**SUBJECT: RESPONSE TO THE NOD FOR TA-0, PRS 0-030(g) RFI REPORT (FORMER OPERABLE UNIT 1071)**

**RESPONSE TO NOTICE OF DEFICIENCY  
FOR TECHNICAL AREA 0, POTENTIAL RELEASE SITE 0-030(g)**

Locations of samples with PCB analytical results in drainage below outfall at PRS 0-030(g).

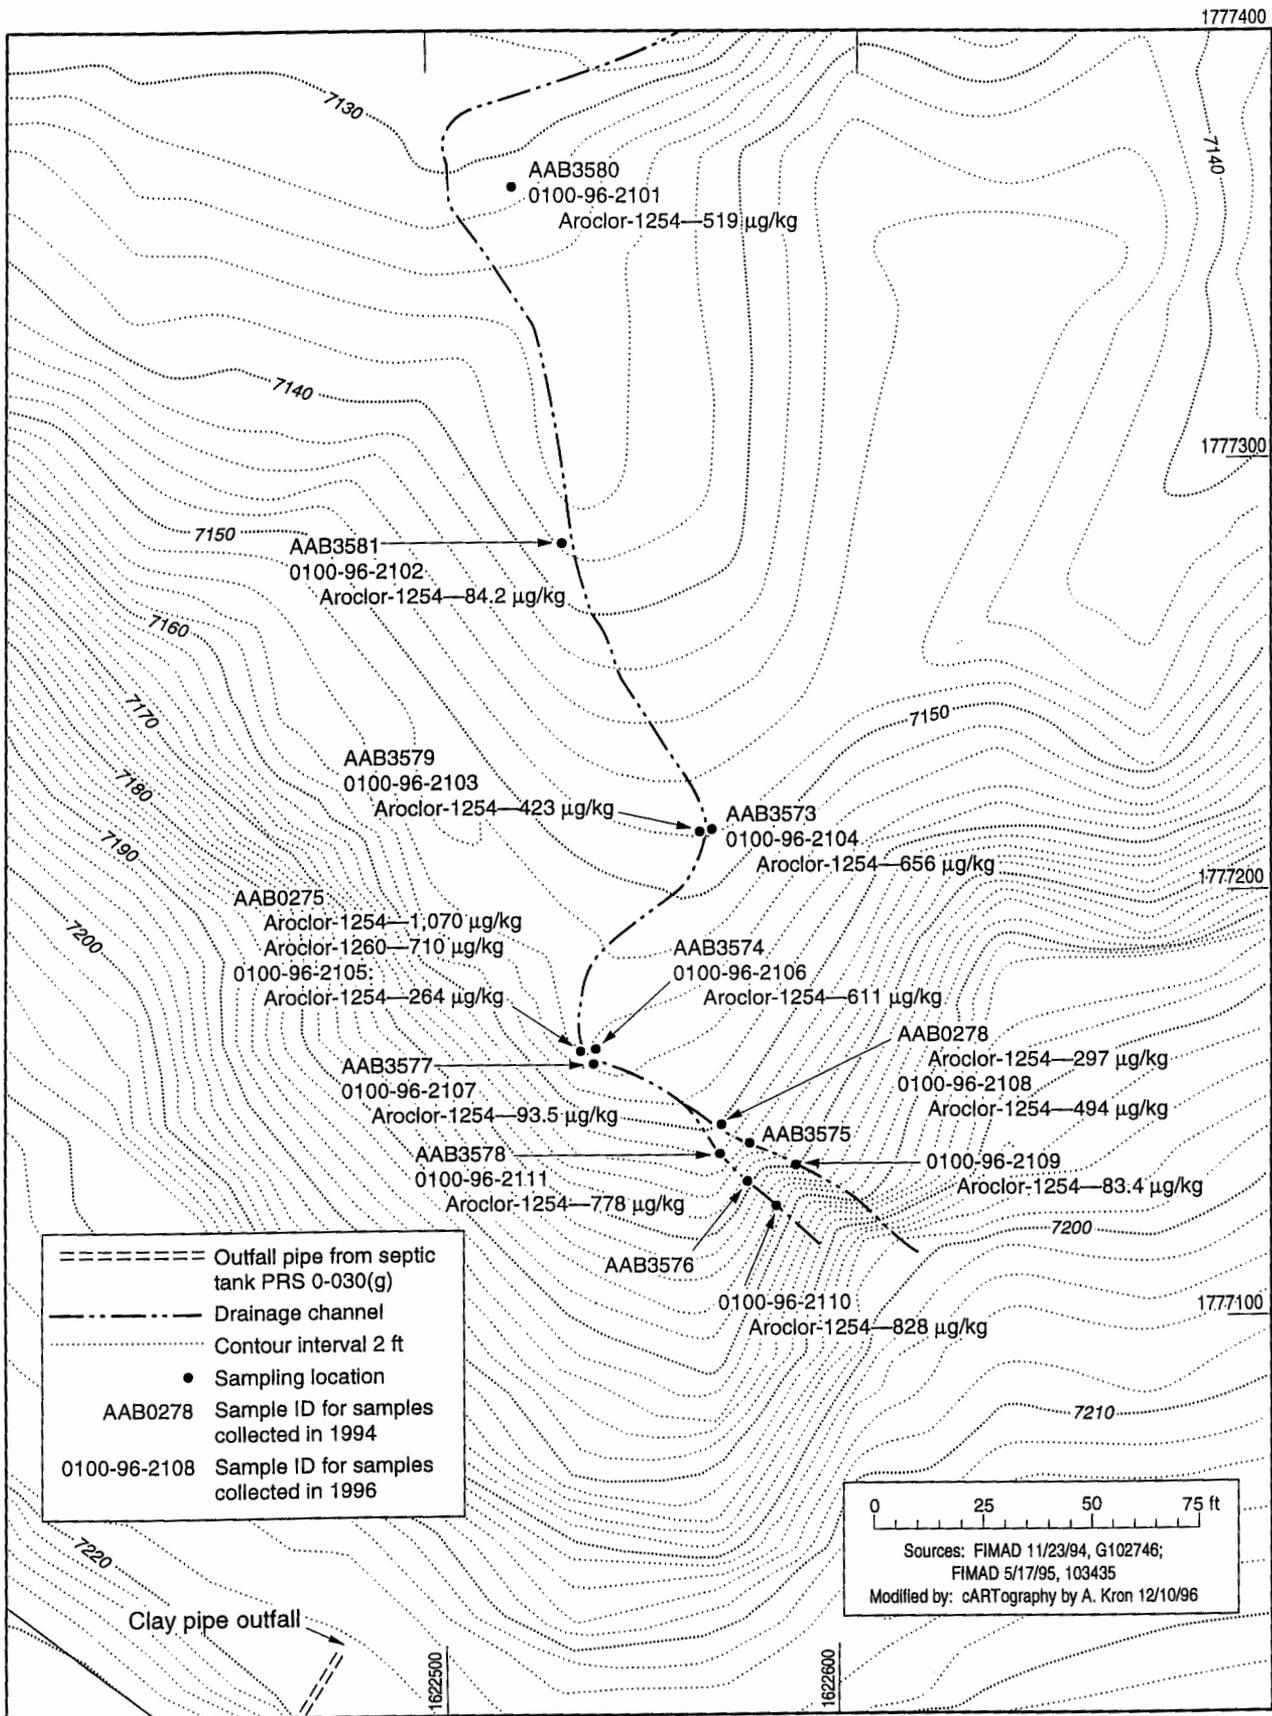
NMED requires DOE/LANL to address all levels of polychlorinated biphenyls above 0.9 mg/kg in any drainage areas and decontamination will be completed to 0.5 mg/kg if those PCBs are in a watercourse. The surface drainage area will need to be included in the ecological risk assessment for this area. Any remediation activities at this site must address these values.

The basis for the values stated in the above deficiency, 0.9 and 0.5 mg/kg, is unclear. The screening action levels for PCBs in soil in the 1990 version of proposed Subpart S, Appendix A, was set at 0.09 ppm. However, EPA had intended to set the level at 1 ppm, based on the TSCA PCB Spill Cleanup Policy for residential land use.

As discussed in Section 4.3 of the RFI Report for PRS 0-030(g), PCBs were detected in one outfall sample at a concentration of 1.78 mg/kg (the sum of two detected values for Aroclor 1254 and Aroclor 1260 in sample AAB0275). This value is slightly greater than the SAL in use at that time (1 mg/kg). PCBs were detected in a second outfall sample immediately upstream from the first sample at a concentration of 0.297 mg/kg, suggesting that the extent of PCBs at concentrations greater than 1 mg/kg is limited. None of the other outfall samples collected as part of the original investigation were analyzed for PCBs. In response to this NOD, additional samples were collected along the drainage channel to further assess the extent of PCBs. The additional samples were generally collected as close to the original drainage channel samples as possible. These additional samples extended from the area above where the septic tank could have drained, to the confluence with Acid Canyon. These additional data, along with the original PCB data, are summarized in Table 2 and Figure 1 of this response.

As shown in Table 2, the maximum detected PCB concentration is 1.78 mg/kg (the sum of two detected values for Aroclor 1254 and Aroclor 1260 in sample AAB0275). None of the other values, including a sample collected in the immediate vicinity of sample AAB0275, contained PCBs at concentrations greater than 1 mg/kg (which, as stated previously, is the level LANL has understood is NMED's remediation level for PCBs in a water course). It should also be noted that PCB concentrations in samples collected above where the septic tank could have possibly drained were similar to concentrations detected in other samples from the drainage channel. These data indicate that the extent of PCBs exceeding 1 mg/kg in soil at PRS 0-030(g) is very limited, and also that the source of the PCBs detected in this drainage channel is possibly unrelated to releases from the septic tank. Therefore, no further action regarding PCBs is recommended at PRS 0-030(g). As stated in the response to Deficiency 3, further ecological risk assessment will be conducted at PRS 0-030(g) once final guidance is received regarding the ecological exposure unit methodology.
